18377_60% Deliverable Combined_WSDOT-Comments.pdf Markup Summary

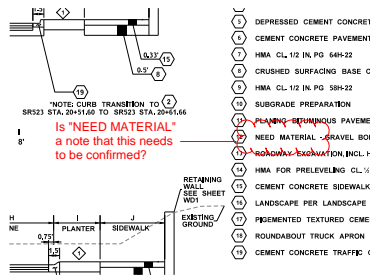
Item is "Precast Dual Faced....", not precast dual face

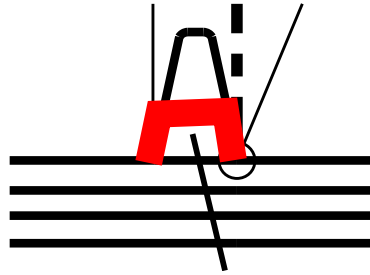
Is "NEED MATERIAL" a note that this needs to be confirmed?

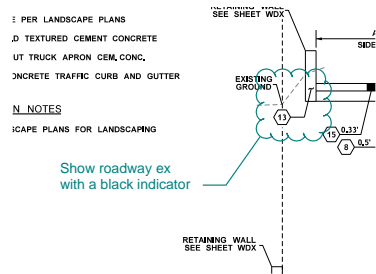
Show roadway ex with a black indicator

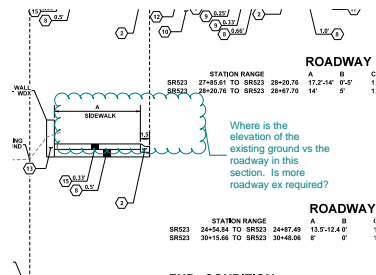
Include roadway ex as above.

Where is the elevation of the existing ground vs the roadway in this section. Is more roadway ex required?

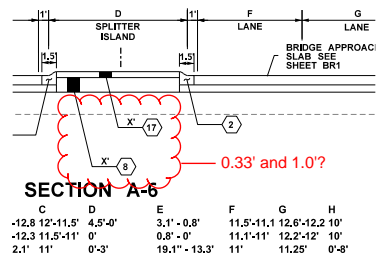
Any way to make these slopes closer to 4:1?

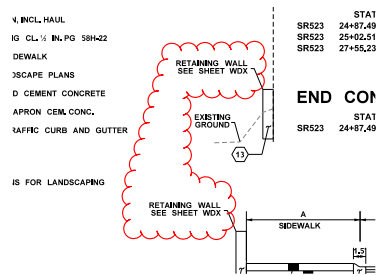
0.33' and 1.0'?

Should be WA1, that way they can find the right wall sheet.

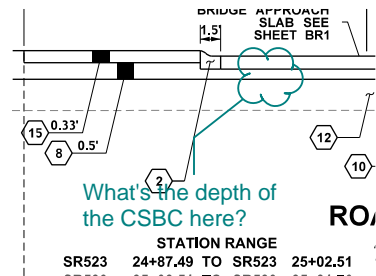
Any way to make the 2:1 slope flatter? If not, make the 2:1 slope appear steeper than the 4:1 slope

What's the depth of the CSBC here?

Sidewalk H should match sidewalk A?

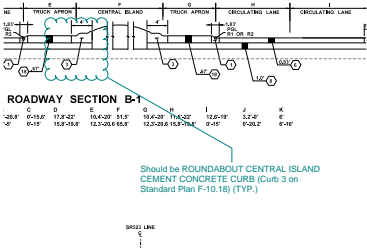
DM 1239.06 says this should be 2' otherwise justification documentation should be provided.

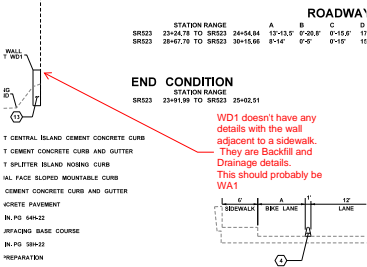
Should be ROUNDABOUT CENTRAL ISLAND CEMENT CONCRETE CURB (Curb 3 on Standard Plan F-10.18) (TYP.).

WD1 doesn't have any details with the wall adjacent to a sidewalk. They are Backfill and Drainage details. This should probably be WA1

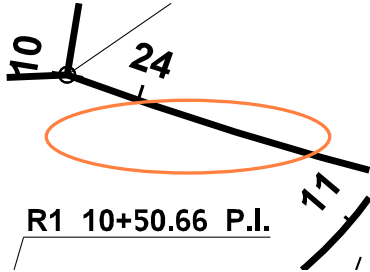
Overlapping text

Missing bearing

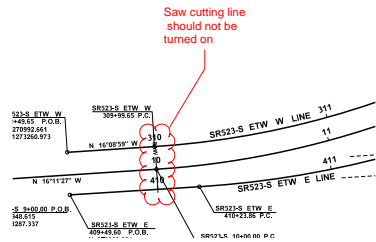
There should be a monument near here.
<https://www.wsdot.wa.gov/monument/report.aspx?monumentid=1743>

Ref No and page was shifted out of place

Names were shifted out of place

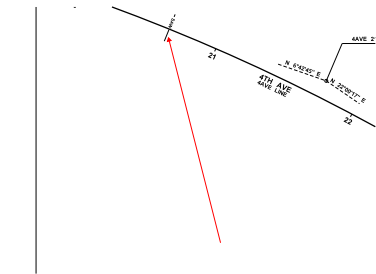
Saw cutting line should not be turned on

There shouldn't be a "Proposed" right of way. The right of way should be shown as what it will be when the contractor is out there.

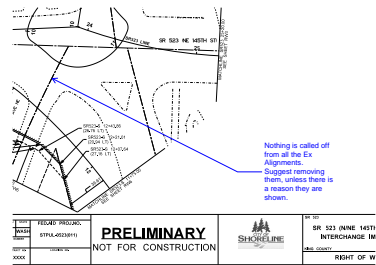
I think this data should probably be on the alignment plan.

Nothing is called off from all the Ex Alignments. Suggest removing them, unless there is a reason they are shown.

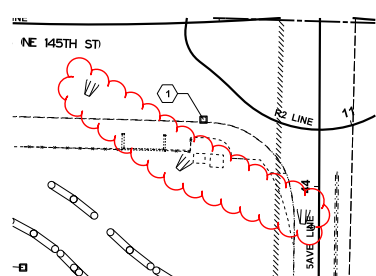
Will this make sense? Won't there be an existing wall here by ST?

Extraneous curb ramp levels turned on

<table><tr><td>Subject: Text Box</td><td>Seeing the Sound Transit piers would be helpful on this sheet. Might be calling out wattles through them.</td></tr></table>

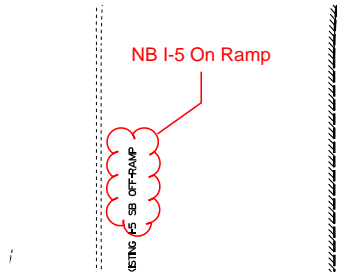
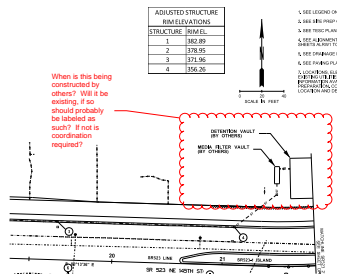
<table><tr><td>Subject: Cloud+</td><td>Does this make sense? Won't there be a wall constructed by Sound Transit at the Access hachure lines? See WA1</td></tr></table>

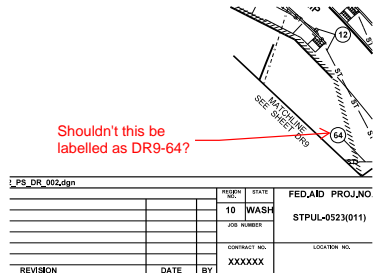
When is this being constructed by others? Will it be existing, if so should probably be labeled as such? If not is coordination required?

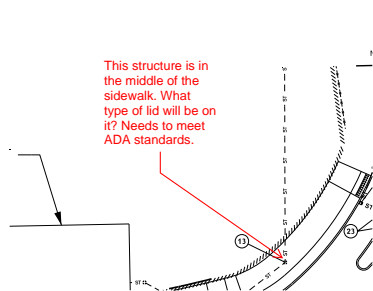
Shouldn't this be labelled as DR9-64?

This structure is in the middle of the sidewalk. What type of lid will be on it? Needs to meet ADA standards.

Would imagine these structures are part of the corridor project. Please ensure there is enough depth to be able to lower them to the new elevations

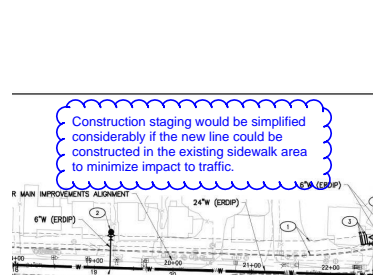
The WA reference is already being used for the wall plans

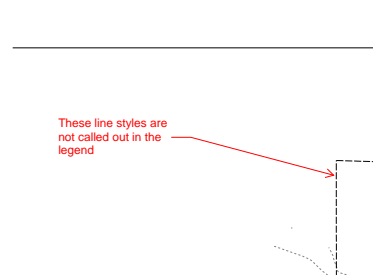
Construction staging would be simplified considerably if the new line could be constructed in the existing sidewalk area to minimize impact to traffic.

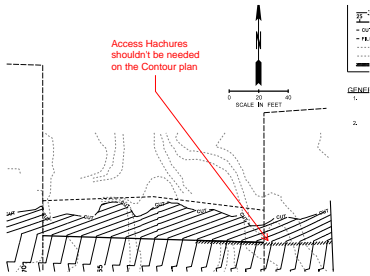
These line styles are not called out in the legend

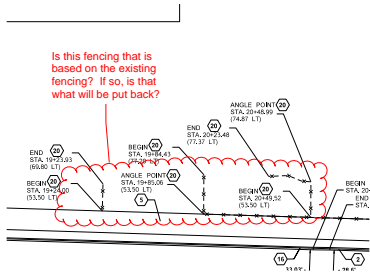
Access Hachures shouldn't be needed on the Contour plan

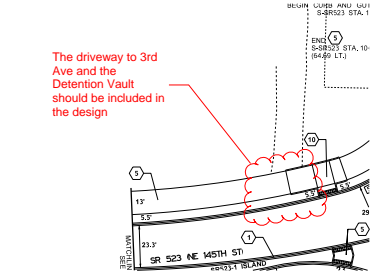
Is this fencing that is based on the existing fencing? If so, is that what will be put back?

This truck apron is not the same scale as plan

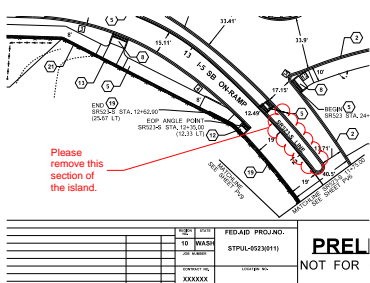
The driveway to 3rd Ave and the Detention Vault should be included in the design

Please remove this section of the island.

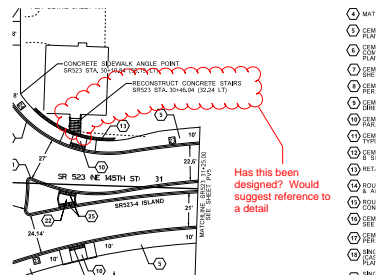
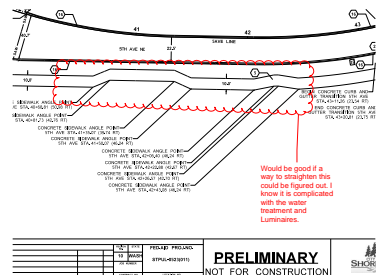
Has this been designed? Would suggest reference to a detail

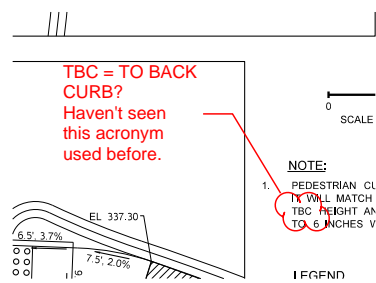
All the dimensions in hatched area are very challenging to read. Please fix.

Impossible to tell direction of slope because arrow heads are tiny.

These ones are also rotated the wrong way because they are past 90 degrees rotated.

TBC = TO BACK CURB?
Haven't seen this acronym used before.

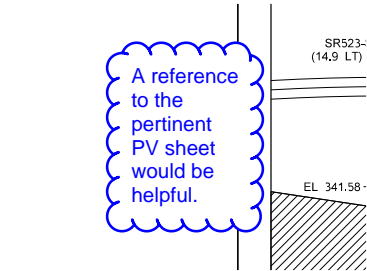
This hatching isn't necessary. The sidewalks and medians are already called out on Paving Plan and Roadway Sections. Hatching just add unneeded clutter.

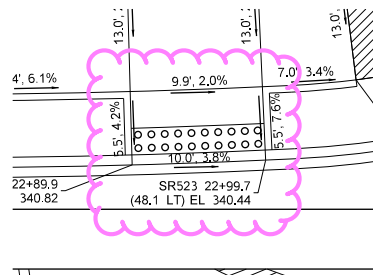
A reference to the pertinent PV sheet would be helpful.

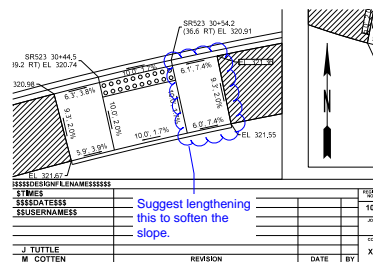
Is it possible to drop the sidewalk down faster from the west so there isn't such a steep ramp here leading into 5th Ave? Would prefer lower than 8.2%

Suggest lengthening this to soften the slope.

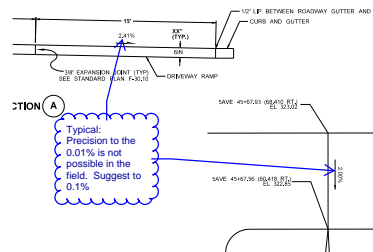
Typical:
Precision to the 0.01% is not possible in the field. Suggest to 0.1%

Only need one label

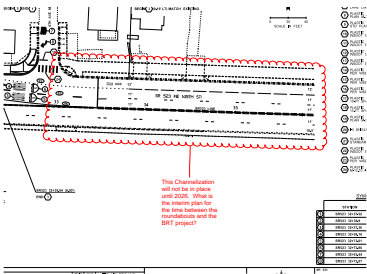
This Channelization will not be in place until 2026. What is the interim plan for the time between the roundabouts and the BRT project?

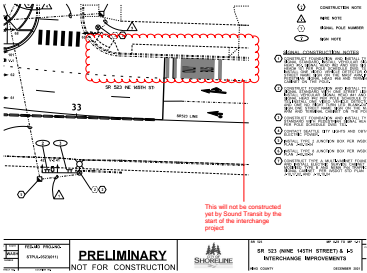
This will not be constructed yet by Sound Transit by the start of the interchange project

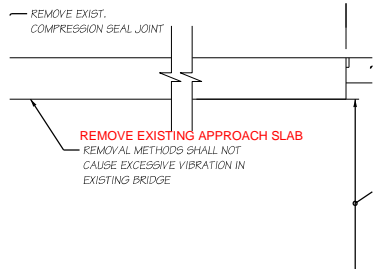
"PROTECT"

REMOVE EXISTING APPROACH SLAB
